# General Motors

COTB 0006

## 'EVAPORISATION CHAMBER' SPECIFICATION CHANGE

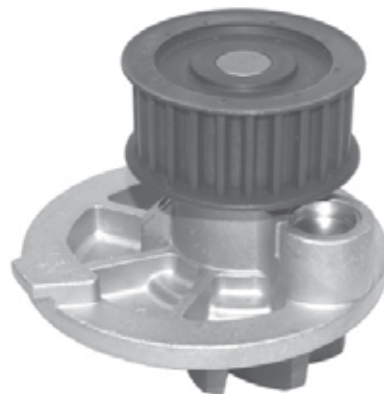
Following design and specification modifications by the Original Equipment manufacturer, First Line has superseded both **FWP1575** and **FWP2073** by a new reference:- **FWP2150**.

The new pump incorporates an 'Evaporisation Chamber' into the design and will fit all applications previously covered by both **FWP1575/2073**.

When viewed in profile, the **FWP2150** is much shallower in depth than the previous design, and care should be taken to ensure that the pump is correctly located in the engine block.
